COUNCIL ASSESSMENT REPORT

Panel Reference	PPSHCC-145
DA Number	DA2022/0390
LGA	MidCoast Council
Proposed Development	School, comprising: • Preparation of the site involving the excavation of the land in the southern parts of the site to create stormwater basins and the filling of land in the northern parts of the site where school buildings are proposed; • Administration Centre – A two storey building containing: ○ Entry foyer; ○ Interview room; ○ Offices; ○ Canteen; ○ Toilets; ○ Learning spaces at upper level; • Two (2) x two storey (2) classroom buildings each containing six (6) individual classrooms; • Outdoor recreation area including a Covered Outdoor Learning Area (COLA); • Vehicle manoeuvring areas and parking for fifteen (15) off-street parking spaces; • Kiss-and-drop area for student drop-off/collection; • Provision for on-street bus parking; and • Provision of necessary services and infrastructure.
Address	Lot 1 DP 1264355 The Southern Parkway, Forster NSW 2428

Summary of key submissions	Traffic / Parking Noise Amenity
Report prepared by	Bruce Moore, Coordinator Major Assessment MidCoast Council
Report date	12 December 2023

Figure 7 – Access and Parking (source: Stanton Dahl Architects)

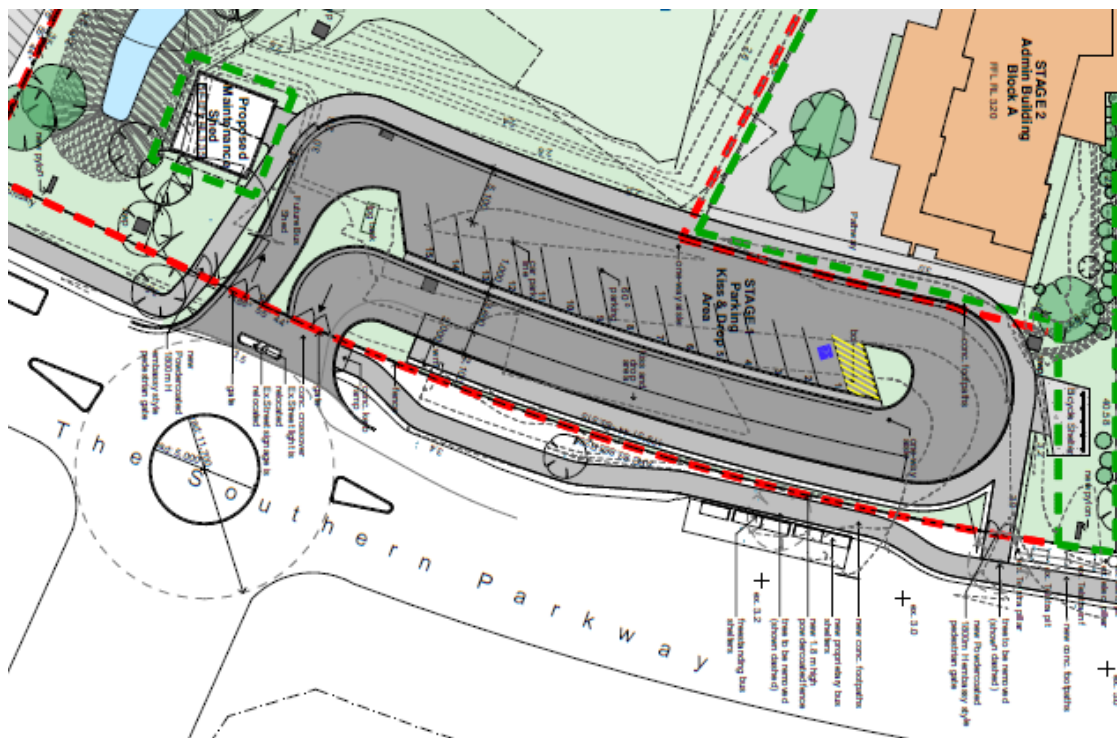
- The application (SEE) proposes that all waste generated by the school is to be housed within mobile garbage bins and taken to the kerbside for collection, which would eradicate the need for a garbage truck to enter the circulation area, however, this would have an impact on available on-street parking and a management plan has not been discussed in detail within the SEE, TIA's or peer review.

- The peer review relies heavily upon the use of the western isle for both AM and PM “kiss and drop” maneuvers to be undertaken that in turn, (in the opinion of the peer review) will reduce the number of on-street parking requirements within the Southern Parkway. The management plan required for this scenario to work proposes the cordoning off (by staff members) of the 15 staff/visitors parking spaces as a maneuver into, and out of these spaces is not achievable with the parallel parking associated with the proposed kiss and drop area.

However, this change could also affect the ability of a service vehicle to perform a one-motion swept path at the northern end of the circulation area without some amendment to the current radius of the turning head.
